ADDENDUM NO. 21

Date: 09.11.2026

**Westfield Washington School Corporation
Bid Package 06, Bid Item #33
SR32 & Centennial Road New Roundabout Construction
17707 Centennial Road,
Westfield, IN. 46074**

ADDENDUM NO. 21

LIGHTING DETAILS

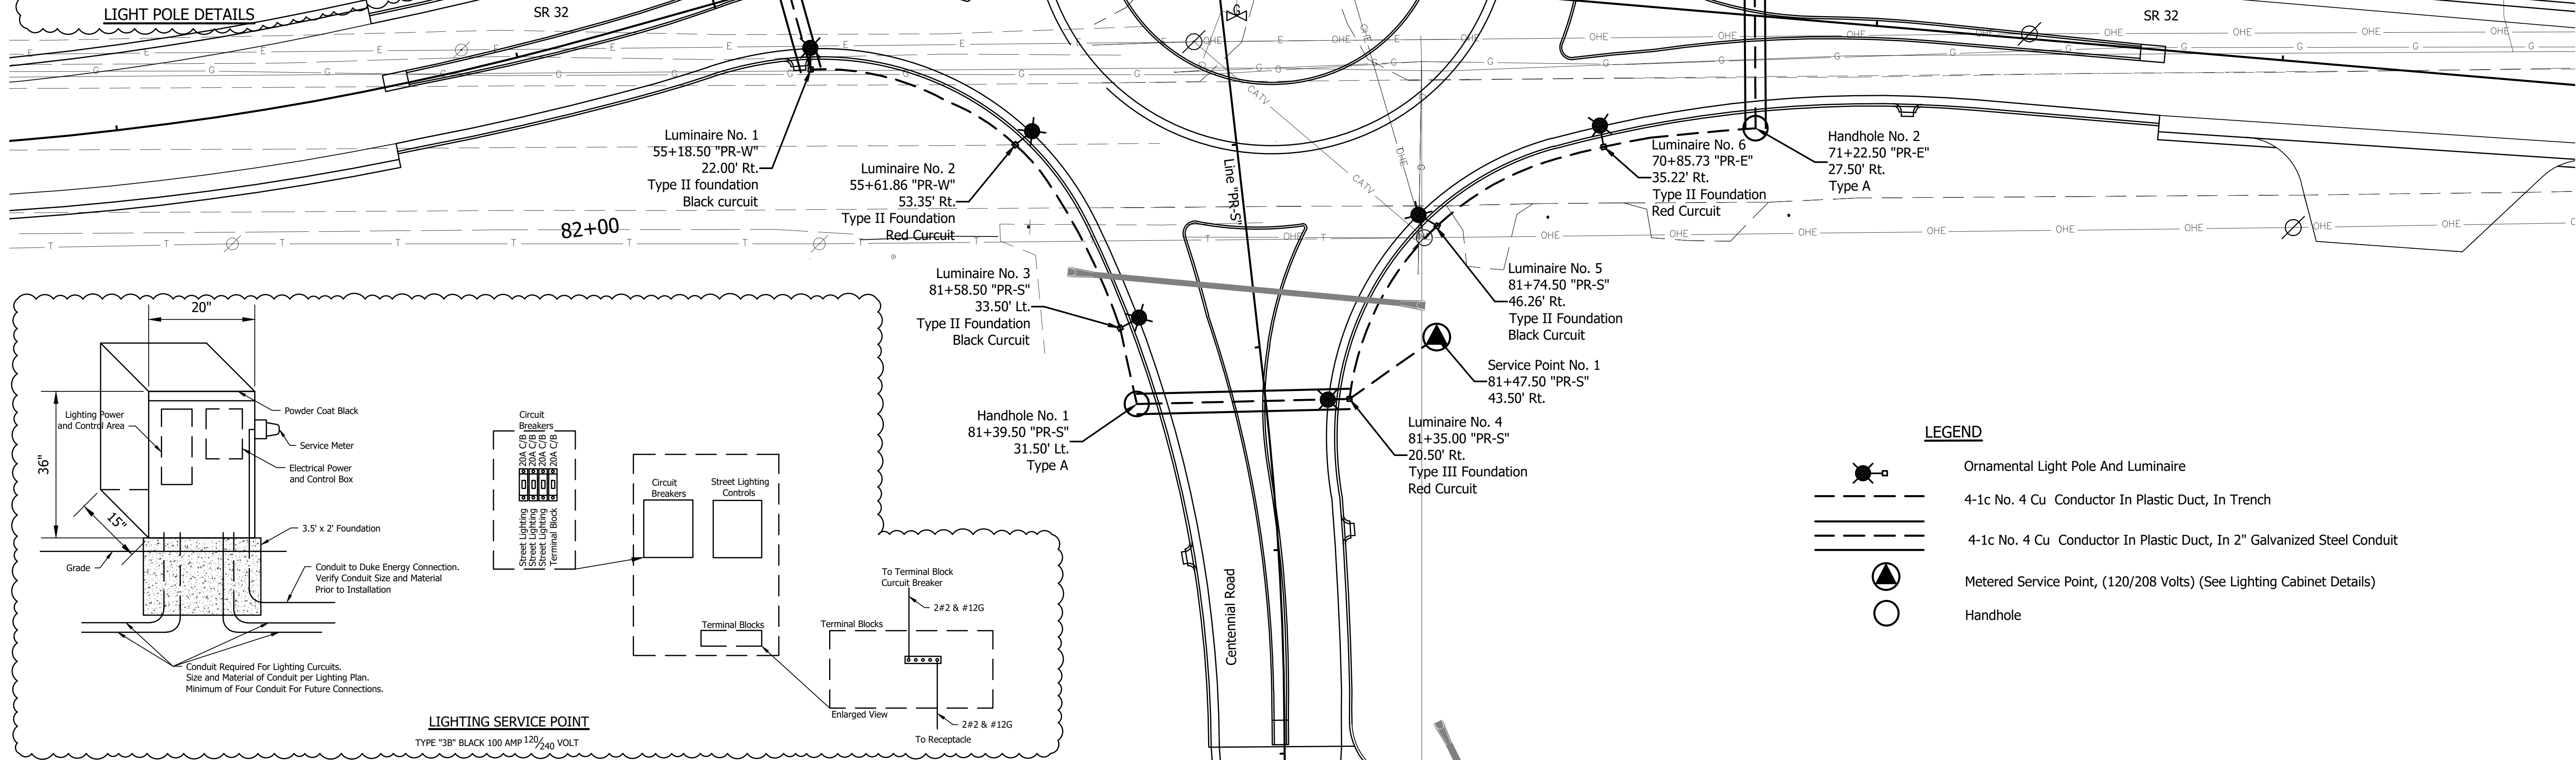
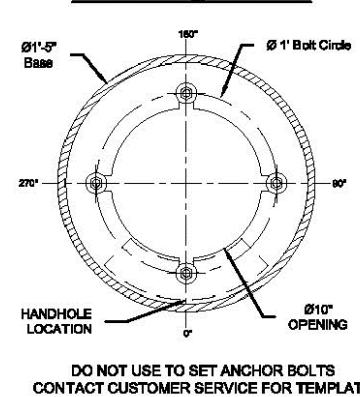
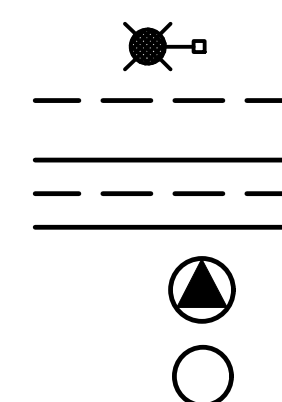
4.2 Drawing Sheet 24 of 47

A. Revised sheet now includes City of Westfield decorative lighting information for use in preparation of bids.

DATE	ITEM
09-10-2026	Lighting Pole and Service Point Details Added

The lighting post shall be all aluminum construction with a decorative fluted cast aluminum base. Shaft profile shall consist of four mounting tracks and channels. The post shall be provided with (1) single roadway arm, 96" from post to luminaire center, (2) banner arms, and (1) leveling fitter.

The base shall be heavy wall, cast aluminum produced from certified ASTM 356.1 ingot per ASTM B-179-95a or ASTM B26-95. The shaft shall be extruded from aluminum, ASTM 6061 alloy. All hardware shall be stainless steel. Anchor bolts to be completely hot dip galvanized.

The post shall be 30'-0" in height with a $\phi 17"$ base. A hand hole shall be provided for access. A $\phi 3 \times 5"$ tall tenon shall be provided for luminaire mounting.

The post shall be provided with four, hot dip galvanized L-type anchor bolts to be installed on a 12" diameter bolt circle. A door shall be provided in the base for anchorage and wiring access. A grounding screw shall be provided inside the base apposite the door.

- 19,000 Lumens: 5 COBs - 4000 Series CCT - Auto-Sensing Voltage
- Black finish - Bowl Glass and Door - Type 3 Asymmetric Distribution
- Quick Look Stem mount - $\phi 30"$ Shallow Skirt for Cutoff Requirement
